APPLICATION NUMBER: 24/1007

PROPOSAL: ERECTION OF A REPLACEMENT DWELLINGHOUSE AND ASSOCIATED HARD LANDSCAPING SCHEME (PART RETROSPECTIVE) (RESUBMISSION OF 23/0853)

SITE: Hillcroft Llandevaud Lane Llandevaud Newport NP18 2AD

<p>Approved</p> 	<p>Proposed</p> 
<p>Approved</p> 	<p>Proposed</p>

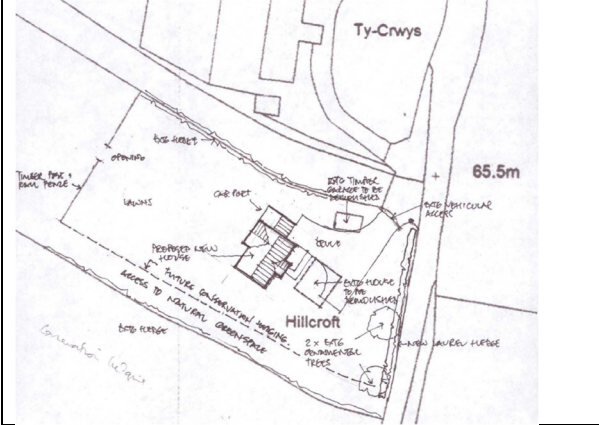
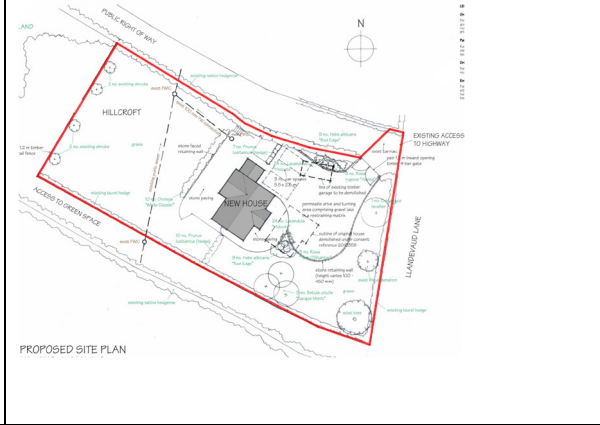
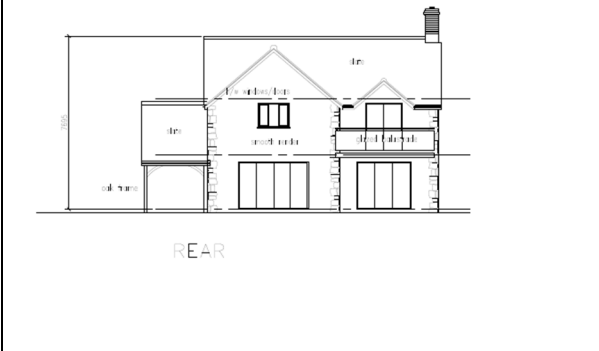
Based on the approved and proposed site plans and rear elevations below the approved rear elevation has a modest first floor glazed balcony, the proposal has an extended balcony along the rear elevation and single storey extension and will be more prominent where visible.

As requested at pre-app stage and previous applications but yet to be submitted, views from a public right of way along the site boundary have not been assessed and so the impact of the proposed change to the rear elevation is unclear - the boundary hedge may provide summer screening but this is not likely through winter months. **Photos are required.**

The Site Plan shows existing planting to be retained and new planting. Tree and shrub planting to the front is adequate but the tree size proposed at 1.5-2m half standard **requires revision to more mature nursery stock.**

No new tree planting is proposed to the rear to break up any views of the rear elevated elevation, and the use of 10no Choisya to break up the long rear elevation wall is inadequate. Planting to the rear is likely to require a more robust approach however this depends on visibility of the rear from the right of way and in the wider landscape which is yet to be evidenced.
